UNITED STATES PATENT AND TRADEMARK OFFICE

APPLICATION NO.	FILING DATE	FIRST NAMED INVENTOR	ATTORNEY DOCKET NO.	CONFIRMATION NO.
09/972,287	10/05/2001	James E. Nelson	14144	4864

Office Action Summary

DETAILED ACTION

FIG. 8

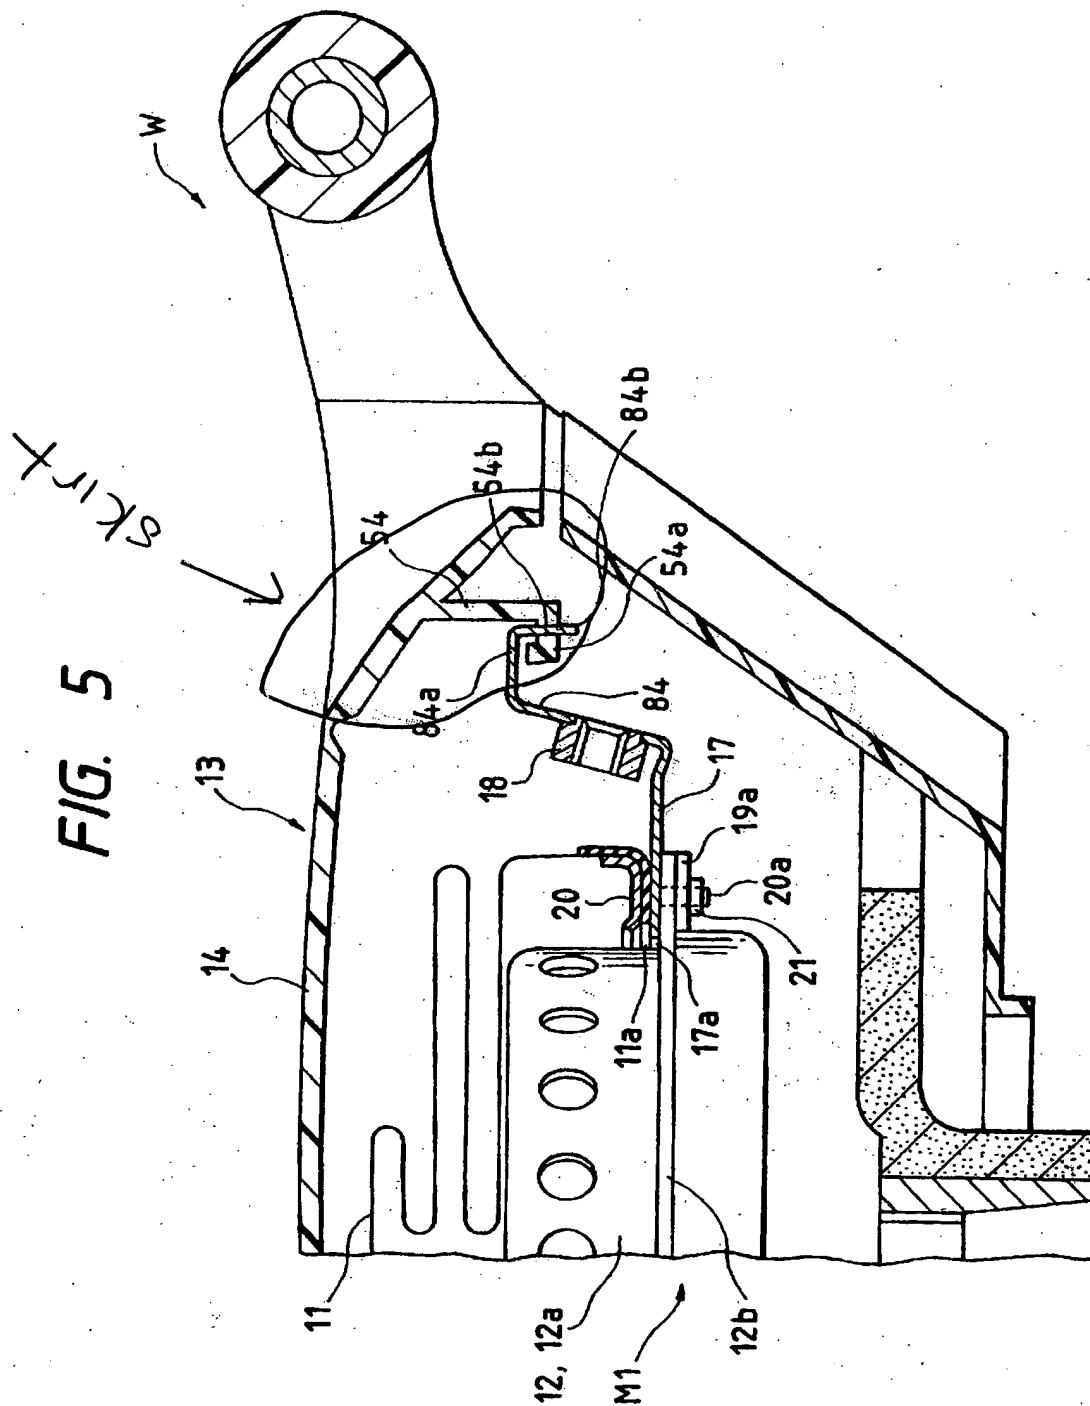
4. The text of those sections of Title 35, U.S. Code not included in this action can be found in a prior Office action.
5. Claims 1-4, 8, 9, 11, 15, 18-24, 29 and 32 are rejected under 35 U.S.C. 102(b) as being anticipated by Yamamoto et al. (US 5,794,968.) Yamamoto et al. teaches an airbag module including a cover (14) and a reaction housing (16, see Figure 6.) The reaction housing includes a plurality of mounting projections (83a, 83b, 84a, 84b) and an integral Z-height control tab (82a) whose top is parallel to the reaction surface (17, see Figure 6.) and the cover includes a plurality of windows (53a and 54b) in a skirt (please note that as broadly claimed, the skirt is considered to be all of the periphery of the cover that descends downward, and includes elements 51-54, and also the entire

downward extending edge of the cover- see attached marked Figures 5, and 8.) The mounting projections engage the window and define a Z-height (as seen in Figure 5) and the control tab engages the skirt and substantially maintains the height (as seen in Figure 4, the height of the bent portion of 82a is such that it allows little play in the slot 52.) Regarding claims 3 and 21, the angle is essentially 0°. Regarding claims 4 and 22, as broadly claimed, the tip of 82a is generally perpendicular to the bottom of the slot 52a (see Figure 4.) Regarding claims 9 and 24, the tab engages the skirt in a net fit (as taught in col. 5, lines 19-17, 82a fits into 52a because 52a is slightly bigger, additionally, the tab holds the skirt between itself and the bracket 19.) Regarding claims 8 and 23, the tab is made from thin sheet metal, and as such is capable of buckling. Please note that regarding claims 2, 20, and 32, Yamamoto et al. teaches that the reaction housing is metal (see col. 4, line 23.) The method of forming the reaction housing (stamping) is not germane to the issue of the patentability of the device itself. Therefore this limitation has not been given patentable weight.
